Architect's Supplemental Instructions Addendum

Project: Samish Xwch'ángteng Development on 34th Street
Anacortes, WA

Addendum/ASI No.: Addendum 01
Date of Issuance: May 9th, 2022

TRAFFIC CONTROL PLAN

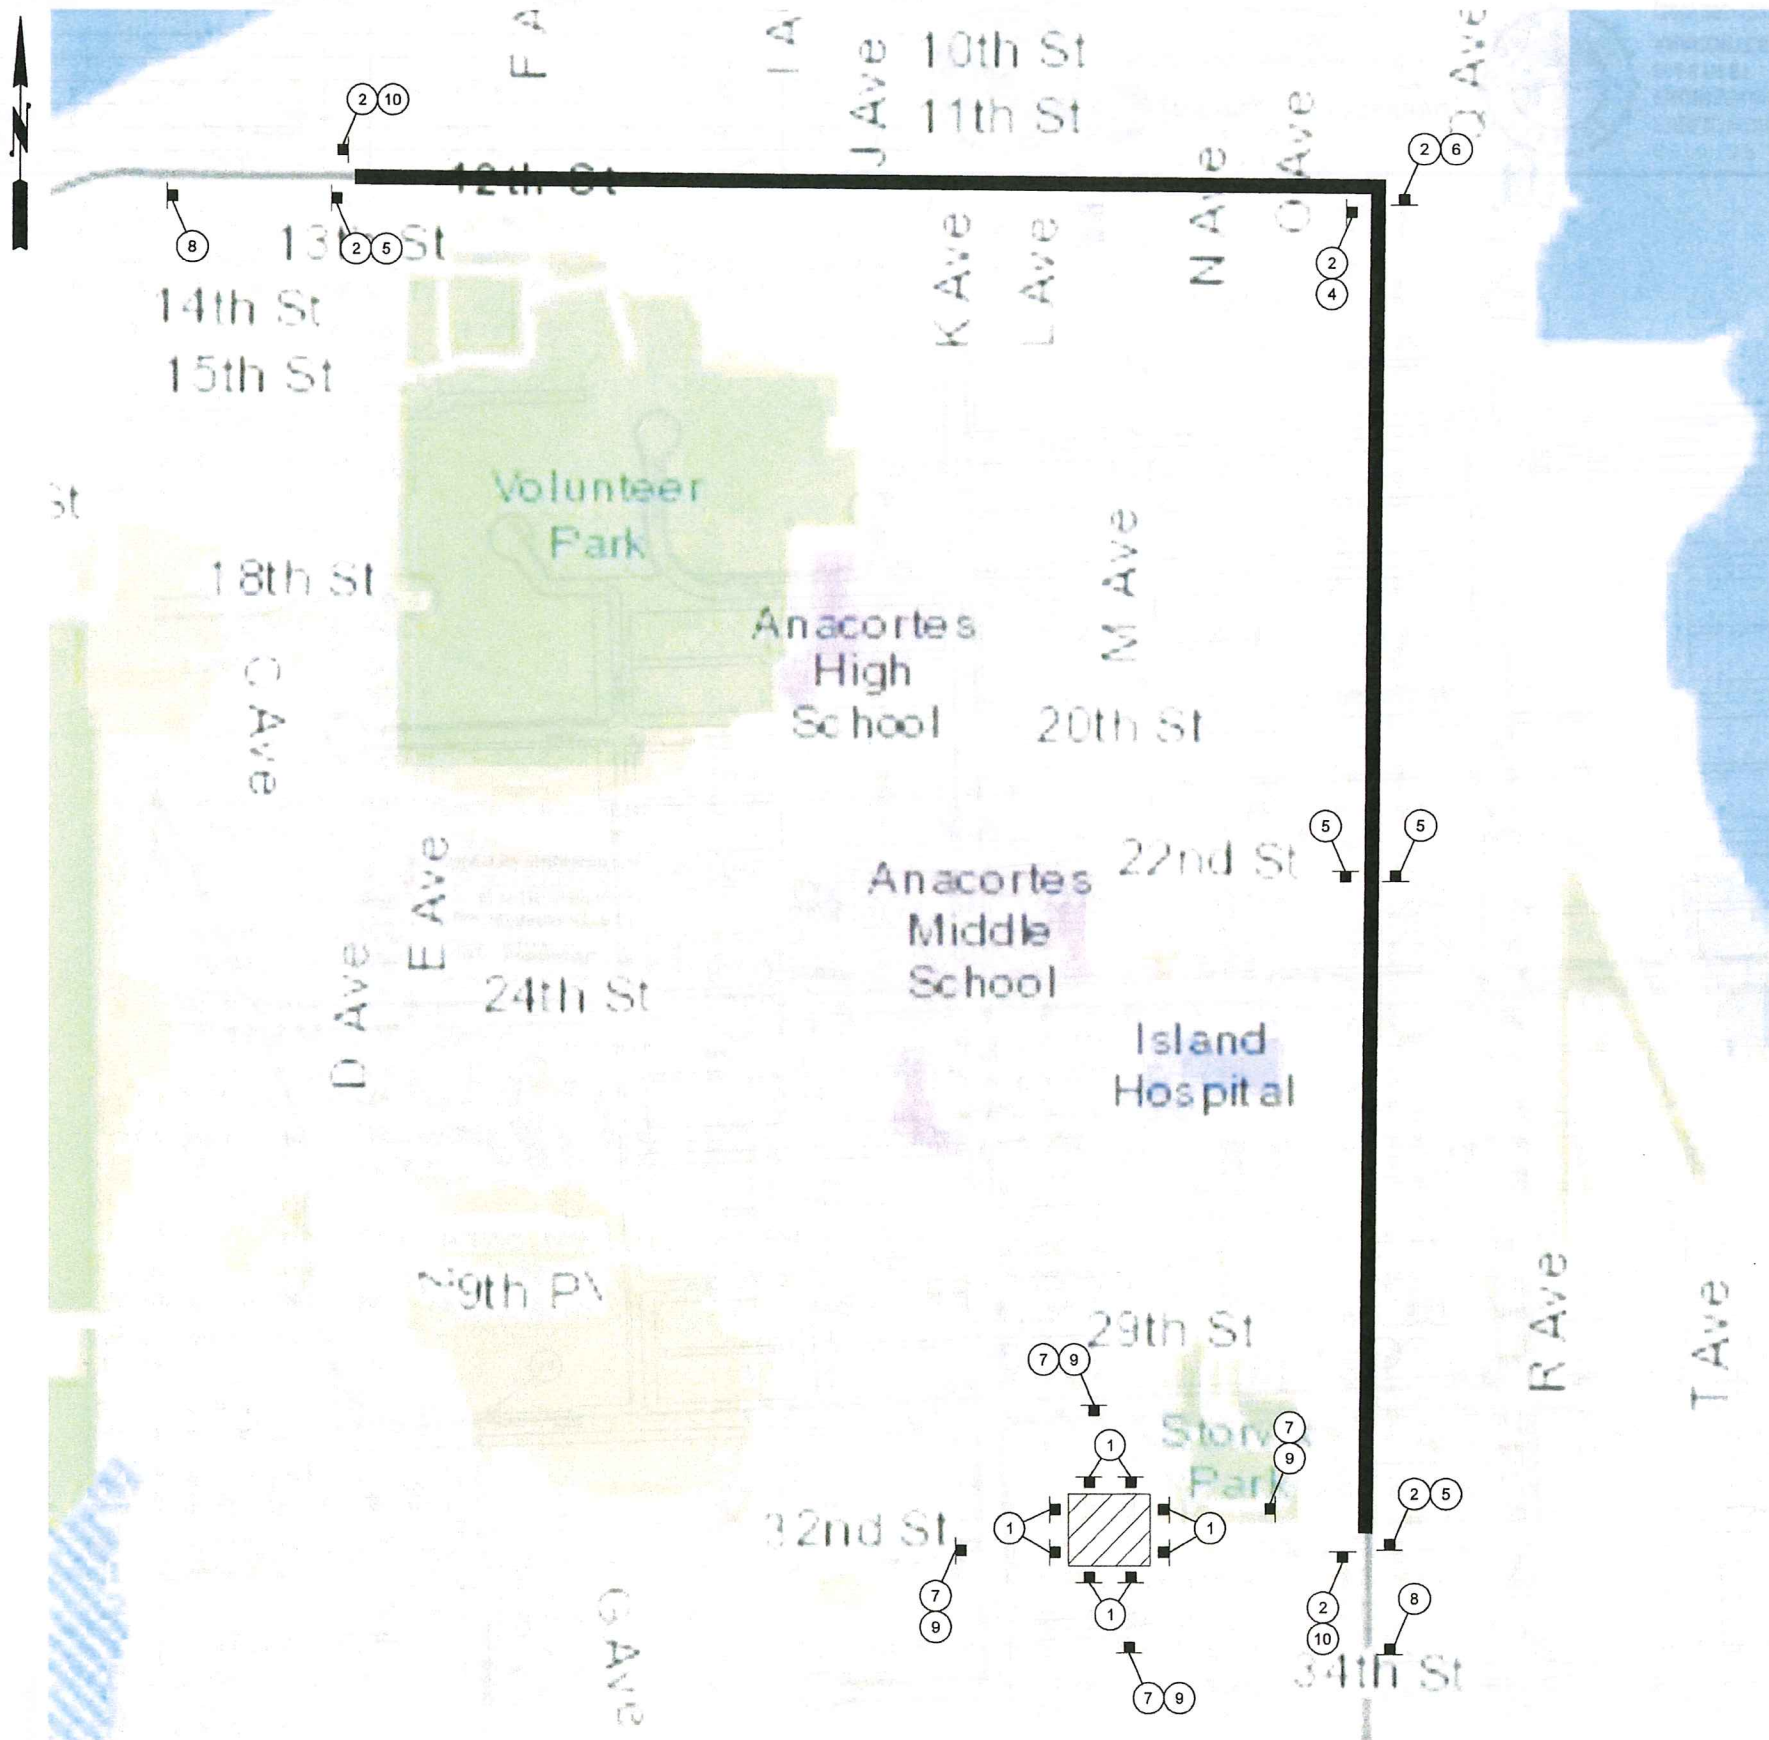
13. Liquidated damages, is there a specific amount or calculation for it? [Question still under review will issue update on next week's addendum.](#)
14. What is required for the street crossing for the storm and sewer at 32nd Street? [Per City Of Anacortes staff:](#)

- Attached is a Tc Plan used for the 32nd and D Avenue Roundabout project for your use and example.
 - Attached is a Tc Plan that was used in the Civil Plans for the upcoming 32nd and M Avenue Roundabout project for your use and example.

- Additionally, you can use a single lane closure (WSDOT Standard Detail).
 - FYI, 32nd Street is a heavily used road for the ferry traffic. Notification of WSDOT and WSDOT ferries is required, as well as the local school bus and transit facilities. City can work with you on this. City suggests, at a minimum for additional Tc measures is the use of PCMS boards at SR20 (east of Commercial Avenue), 32nd and M Avenue, 12th and D Avenue (west of the intersection).

- The trench zone backfill, including pipe zone can be C.S.T.C, compacted to 95% to the bottom elevation of the existing asphalt grade. Or for provide the top 3-feet of the trench zone with CDF (City Standard) to the elevation of the exiting asphalt grade. The CDF typical cure time is roughly 6-8 hours before you can pave the trench crossing.
